INDIANA DEPARTMENT OF TRANSPORTATION

APPROVED MINUTES

April 18, 2024, Standards Committee Meeting

Standard Drawing:
E 609-RCBA-04

E 609-RCBA-04 REINFORCED CONCRETE BRIDGE APPROACH SECTION, PAVEMENT LEDGE, AND BAR BENDING DETAILS (with shown markups)

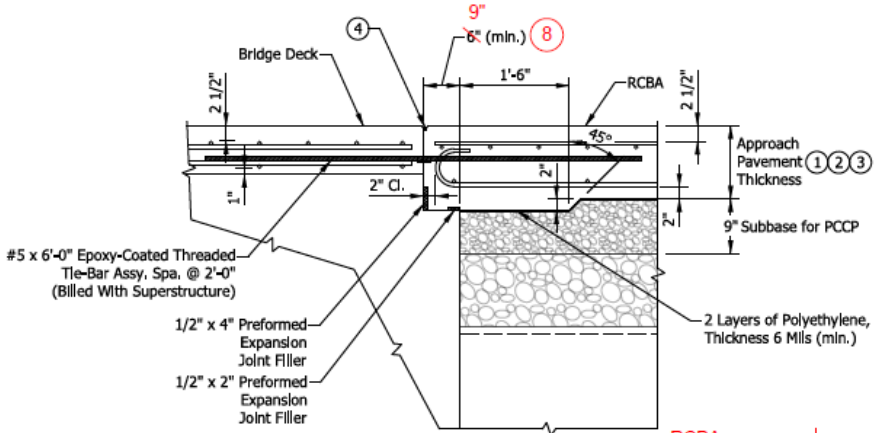
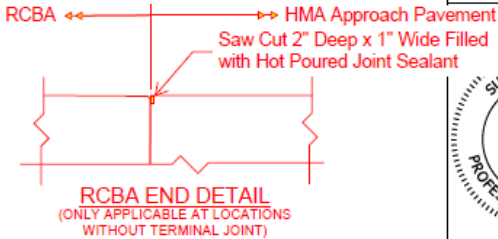
PROBLEM(S) ENCOUNTERED: The current standard pavement ledge width of 6” can create vulnerabilities to future settlement of the RCBA relative to the bridge deck. The concrete-to-concrete bearing width is only 3 ½” after subtracting the widths of the PEJF material, so even a relatively small amount of deterioration or poor concrete consolidation can result in insufficient bearing capacity, which can lead to settlement. It has also been observed that the interface between the end of the RCBA and adjoining HMA pavement, when no terminal joint is required, can develop a slight separation that can allow water infiltration.

PROPOSED SOLUTION: Increase the standard pavement ledge width from 6” to 9” and add a detail to seal the interface between the end of the RCBA and adjoining HMA pavement when no terminal joint is required.

This item was introduced and presented by Mr. White, who stated that the current standard pavement ledge width of 6 in. can create vulnerabilities to future settlement of the RCBA relative to the bridge deck. The concrete-to-concrete bearing width is only 3 ½ in. after subtracting the widths of the PEJF material, so even a relatively small amount of deterioration or poor concrete consolidation can result in insufficient bearing capacity, which can lead to settlement. It has also been observed that the interface between the end of the RCBA and adjoining HMA pavement, when no terminal joint is required, can develop a slight separation that can allow water infiltration.

Mr. White proposed to increase the standard pavement ledge width from 6 in. to 9 in. and add a detail to seal the interface between the end of the RCBA and adjoining HMA pavement when no terminal joint is required.

Mr. Reilman asked how the joint between the RCBA and the adjoining HMA will be filled. Mr. White said it will be Hot Poured Joint Sealant as shown on the drawing. Mr. White said a RPD may be helpful until the revised standard drawing is effective.
